SUBJECT: UNIVERSITY OF VIRGINIA CAVALIER - AMENDMENT RE ADMINISTRATIVE
CONTROLS (TAC NO. MA8249)

AMENDMENT TO FACILITY OPERATING LICENSE

Amendment No. 9
License No. R-123

SAFETY EVALUATION BY THE OFFICE OF NUCLEAR REACTOR REGULATION

FIGURE 6.1 "A"
ORGANIZATIONAL CHART
UNIV. OF VIRGINIA NUCLEAR REACTOR FACILITY
(PRIOR TO SHIPMENT OF ALL FUEL ELEMENTS OFF-SITE)

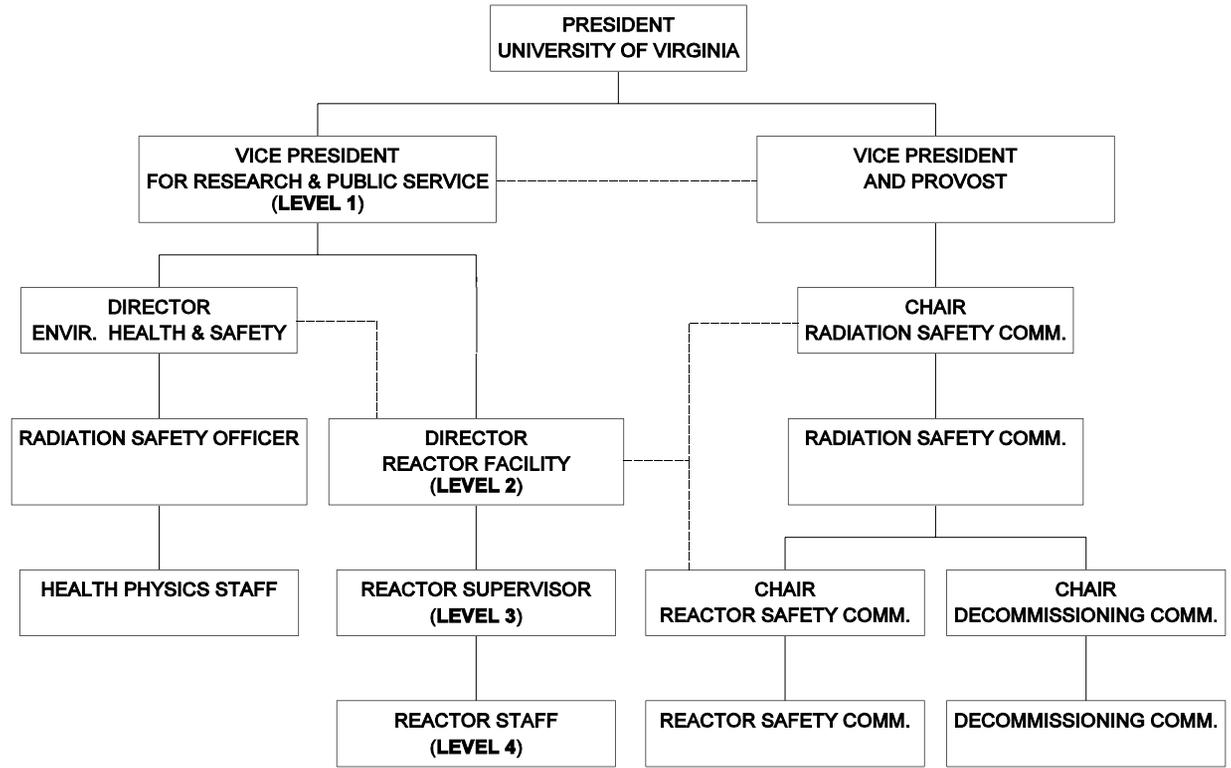
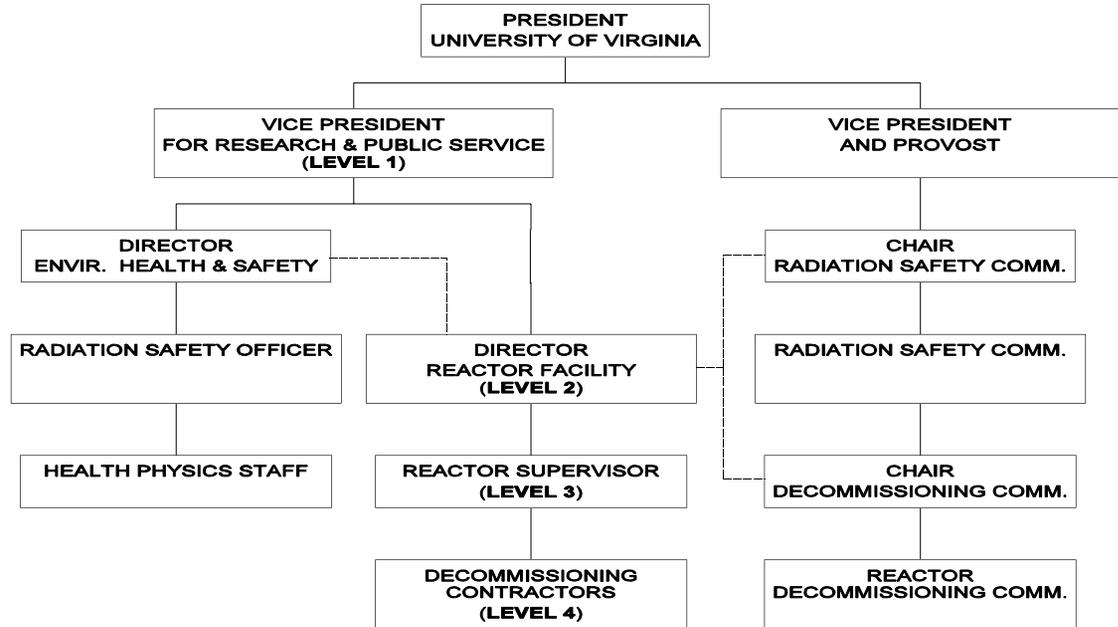
The Reactor Facility shall be an integral part of the University of Virginia. The organizational structure of U.Va., relating to the Reactor Facility is shown in Figure 6.1. The Vice President for Research and Public Service (Level 1) shall have overall responsibility for management of the Facility. The Reactor Decommissioning Committee Chair shall be responsible for advising the Reactor Director (Level 2) on all matters pertaining to the decommissioning and decontamination of the University of Virginia Reactor Facility. The decommissioning committee members may include reactor staff from Level 3, and employees from the Office of Environmental Health and Safety.

Section 6.1.1 of the CAVALIER TSs, "Structure," describes the structure of the organization of the reactor facility as related to UVA and refers to an organizational chart. The licensee has requested changes to this section and the organizational chart that will make them identical to the corresponding section and chart in the UVARR TSs. The existing organizational chart in the TSs (reflecting the organization before shipment of all fuel elements off site) is updated to reflect the current organizational structure of the University and to add a Reactor Decommissioning Committee. A new organizational chart is added to reflect the organization after all fuel elements are shipped off site and the Reactor Safety Committee is eliminated. This TS section continues to describe the structure of the organization of the reactor facility. Because this TS is identical to the corresponding UVARR TS, the changes are acceptable to the staff.
